Access Compliance Report Public Rights-of-Way (Pedestrian Signals)

Main Street: PROSPECT_AVE Cross Street: 17TH_ST Location: NE

ADA ID: SGRK220124104526 Signal Type: One Push Button-Non APS Overall Compliance: No Severity Scores: BTN 1: 35 BTN 2: N/A No BTN: N/A

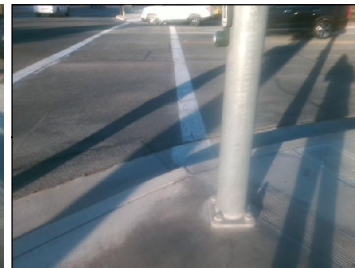
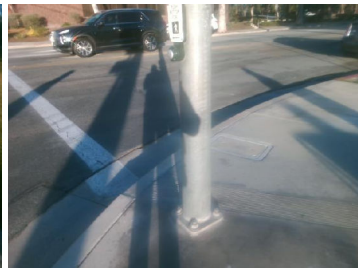
OC Std/PROW: R404.2, R404.3, MUTCD 4e.08

Possible Solutions: Replace Signal Push Button With APS Button. Remove and Replace Clear Space.
